Historic Architectural Review Commission Staff Report for Item 20

To:	Chairman Haven Burkee and Historic Architectural Review Commission Members
From:	Daniela Salume, MFA Historic Preservation Manager
Meeting Date:	June 24, 2025
Applicant:	Alex Sainato
Application Number:	C2025-0058
Address:	812 Carsten Lane

Renovations to historic house. New addition on north elevation behind screen porch, new pool, new cabana, new addition at rear, and site improvements.

Proposed First Floor Plan.

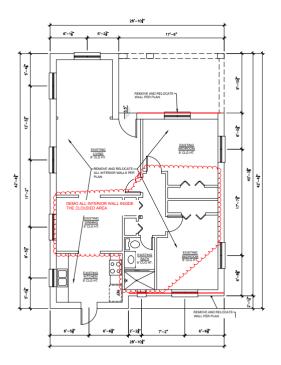
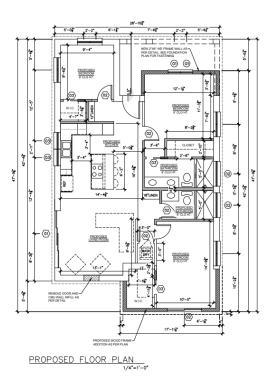
The proposed rear addition would extend the right side of the south elevation. This addition follows many of the Guidelines for Additions. This includes Guideline 27 which states that "changing historically used materials and textures on contributing buildings in order to match a proposed addition is prohibited." The new addition will match the current structure in wood siding and 5-v crimp metal roofing. Guideline 6 states that "whenever possible, additions shall be attached to the rear or least conspicuous side of an existing buildings." The addition is proposed on the rear and least visible elevation. The new addition also follows Guideline 11 which states, "additions to contributing and historic buildings shall limit its size and scale in relationship to the historic building. The addition shall be lower than the original building height." The proposed addition will be lower than the addition would also include a new glass door, which follows Guideline 12 of Entrances, Porches, and Doors which states "sliding glass doors are not appropriate for use on any publicly visible façade of a contributing historic structure." The glass door would be on the south (rear) elevation, not visible from the street.

The proposed east elevation would include four new casement windows. Windows need to match existing configuration as shown in the historic photo from 1965. Shutters were not addressed in this application. Guideline 6 of Guidelines for Windows, Storefronts, Shutters, and Window Protection states that *"replacement windows on buildings or additions that were built in or after 1945 can be of different types, particularly buildings with jalousie and awning windows. Impact resistant windows, either wood, metal, or metal or composite clad, with matching opening dimensions, are an acceptable solution as replacements."* The structure was built after 1945, so the proposed windows can be aluminum.

The proposed west elevation includes a sliding glass door. The sliding glass door will be set back on the west elevation, which will be slightly visible from the street. The cabana will provide a buffer for the door to not be completely visible from the street. The cabana will have a louvered wall. There were no elevations provided for the cabana, so it is unclear if it follows the Guidelines for Outbuildings: Carports, Gazebos, Garages, Sheds, Shelters, & Accessory Structures.
